Proposed Lidl Store, Bankwood Way, Birstall, West Yorkshire

GB Card & Partners (GBCP) have been commissioned by Beam Consulting Engineers Ltd (Beam Consulting) (the Client) to undertake a geotechnical assessment of the proposed ground improvement works at the above site.

Figure 5: Typical cross-section of foundation and ground floor slab over CMCs

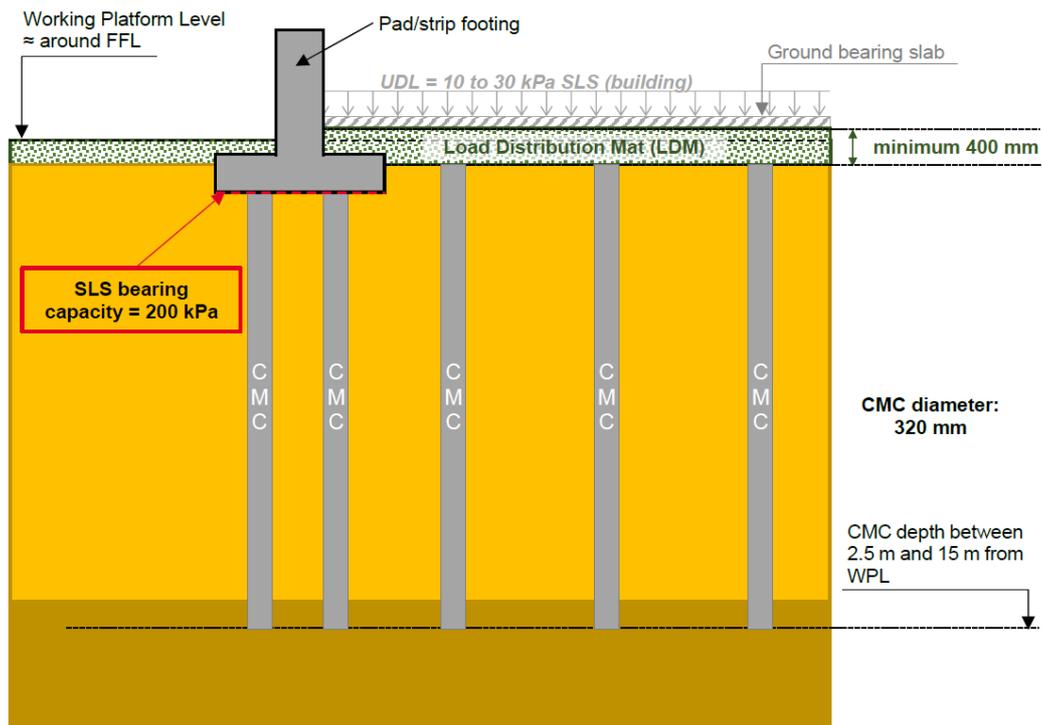
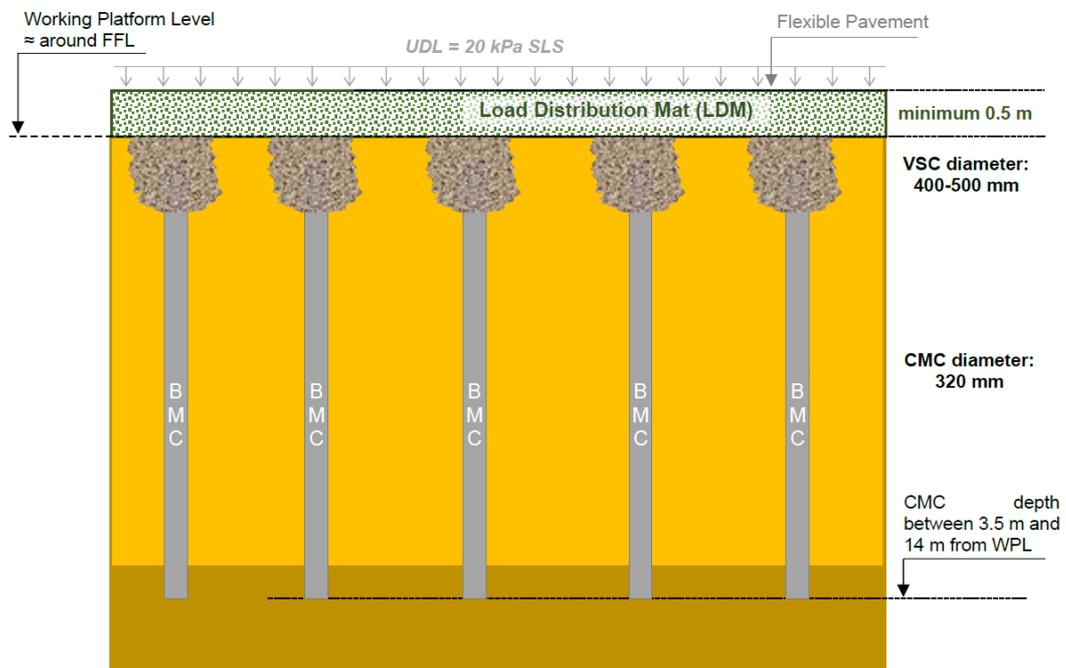
1. The profile of the Pennine Lower Coal Measures Formation varies significantly across short distances. It will therefore be necessary to consider how the base of the columns will be installed without deflection and with sufficient penetration into competent natural material around the edge of the former opencast workings, where interacting with the highwall.

2. It is noted that the waste is described as being within a clay matrix. The clay matrix will generally dominate the geotechnical engineering behaviour of the waste albeit variation will occur given the heterogeneity of the material composition. With landfilling at the site potentially continuing until the early 1990s, it is possible that any biodegradable putrescible materials in the waste are still degrading, albeit most of the degradation should have occurred over the past 30 years. Following improvement, the long-term residual degradation of landfill waste materials, resulting in potentially uneven loss of strength within the soil mass, should be considered. Where long-term settlement occurs within the waste mass, confirmation should be provided that any reduction of support and/or movement will not adversely affect the proposed solution, resulting in excessive movement or collapse of the stone column section.

3. It is acknowledged that anticipated total and differential settlements are to be reduced through the application of the proposed method. It is recommended that the design considers the transition between differing foundation types (CMC's/BMC's) to minimise potential differential movements and to maintain transition gradients within acceptable tolerances. It is anticipated the use of the load transfer mat will mitigate the majority of these potential effects.

4. The potential for ground gas migration, particularly within the vibro stone column element of the BMC columns, should also be considered when designing the system. For example, it may not be feasible to locate the base of the stone columns within the landfill waste material, encountered from depths as shallow as 0.8m bgl, which may mean varying the depth of the stone columns across the site.

6. Excessive heave should be mitigated against during the ground improvement works, as this will reduce the effectiveness of the improvement of soils surrounding the columns. It is assumed the surcharge loading from the addition of the load distribution mat will be minimal and supported by the columns and will therefore not significantly increase consolidation settlements.
